Technical product information

Topic	Luggage compartment lid power open function fails using key fob
Market area	Bentley: worldwide (2WBE),Hongkong-Macau (5HK)
Brand	Bentley
Transaction No.	2046842/1
Level	EH
Status	Approval
Release date

Continental GT Convertible

Figure 1

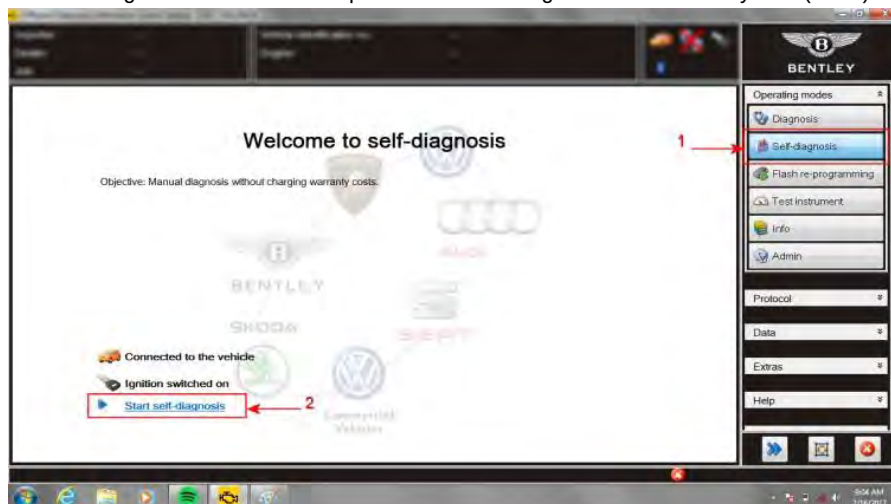
Boot lid control unit software error. Software 0804 may not always trigger a power open operation when initiated via the remote control key luggage compartment lid button (see Figure 1)

New boot lid control unit containing revised software. Software level 0805 or higher is good

Figure 3

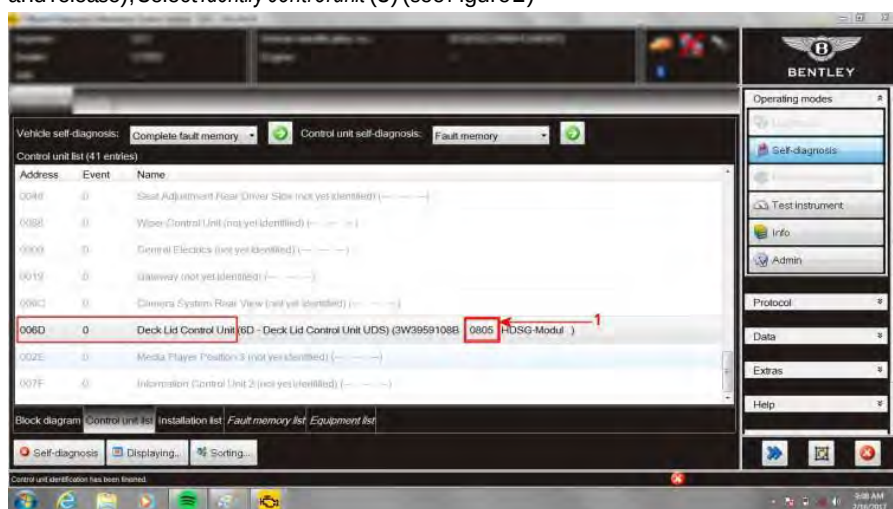
- With 006D Deck Lid Control Unit identified check the software level, data 1 in figure 3. If the software level shown is 0805 or higher the software has no error therefore this TPI is not relevant. If the software level shown is 0804 then replace the boot lid control unit. Refer to workshop manual Rep.Gr.97 Boot lid control unit (J605) – To remove and fit
